## LYNK II/LITE CLOSED LOOP: UNDERCHARGING BATTERIES

CSB Number	855-0017 REV D
Date	Feb 3, 2025

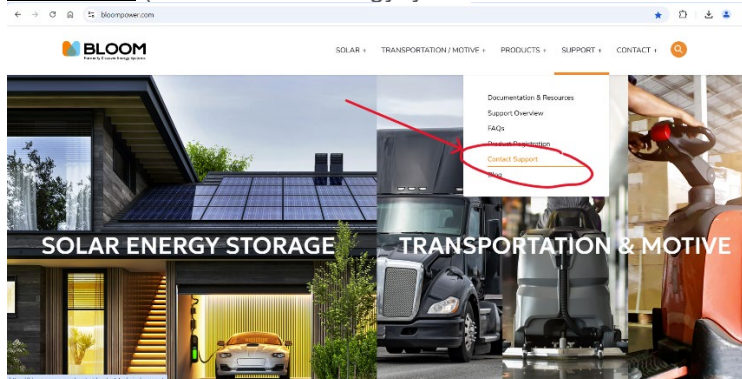
Discover lithium batteries are being undercharged when they are in closed-loop communication using a LYNK II or LYNK Lite Gateway with a firmware version before 2.0. Undercharging occurs because the charge voltage delivered to the battery is below the required voltage to charge. The condition can be observed by using LYNK ACCESS software to view the actual charge voltage delivered and comparing with the charge voltage displayed by the power equipment. Corrective action is required if a significant difference between the target and actual voltage is observed.

The inverter-charger receives the target charge voltage from the battery's BMS, but the inverter delivers a lower voltage at the battery terminals. This significant voltage drop will prevent full battery charging.

Update to LYNK ACCESS software version 2.0 or later, which will reset the Max Charge DeltaV limiting value and raise the charge voltage delivered to the batteries.
